SEWAGE DISPOSAL TESTING

SUBDIVISION Highland Acres LOT NO. 4, Sec. 1

RE: Highland Acres, Lot 4, Sec. 1
Brown Bridge Road
Highland, Howard County, Md.

2 1/2 HIGHLAND
ACRES
Lot 4 part 1

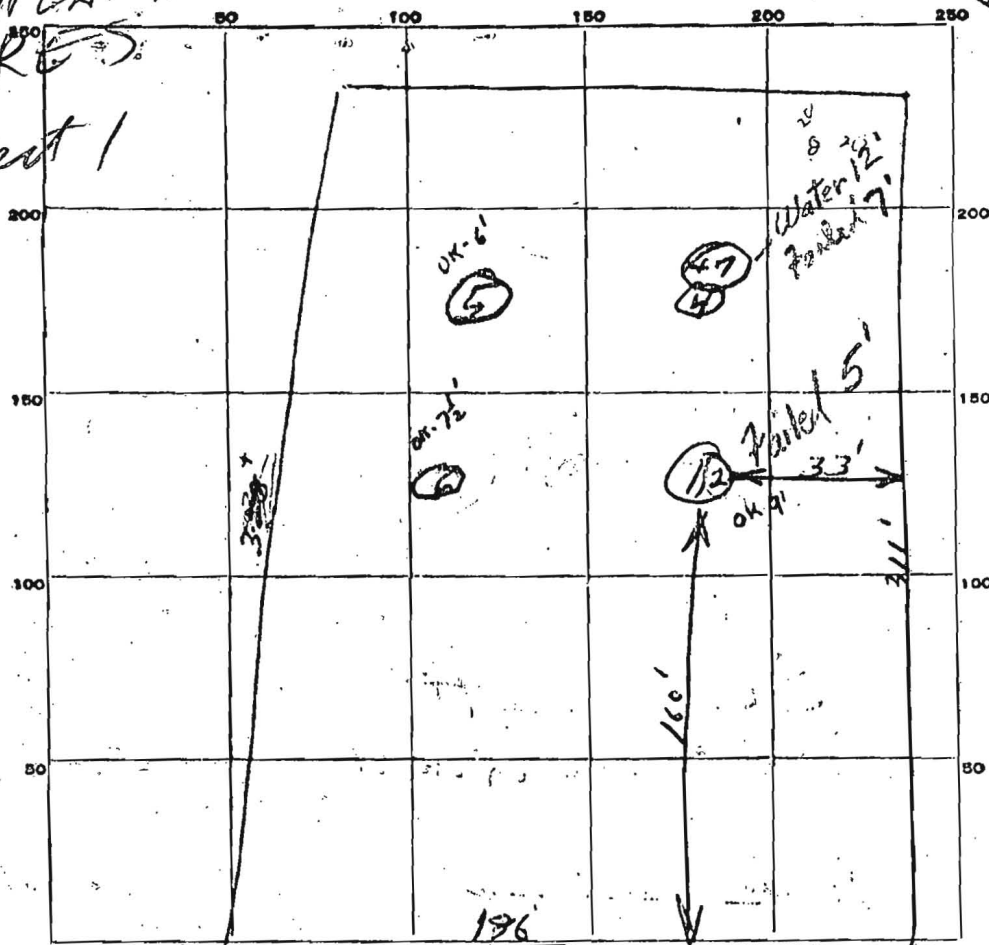
This lot passed the standard percolation test and is considered buildable providing:

- a grading plan is received showing the house sewer can enter the high part of the sewage area (25' from road and 65' from left side) no deeper than 4 ft. below original grade
- the house site is shown 20 ft. or more away from the sewage disposal area - (a line drawn between the two perc holes 60'-65' from the front of the lot)
- the well is located at a higher elevation than the sewage disposal area and 75' to 100' removed - (front right corner of property)
- the well and the septic system are installed, before the building permit is approved by the Health Department.
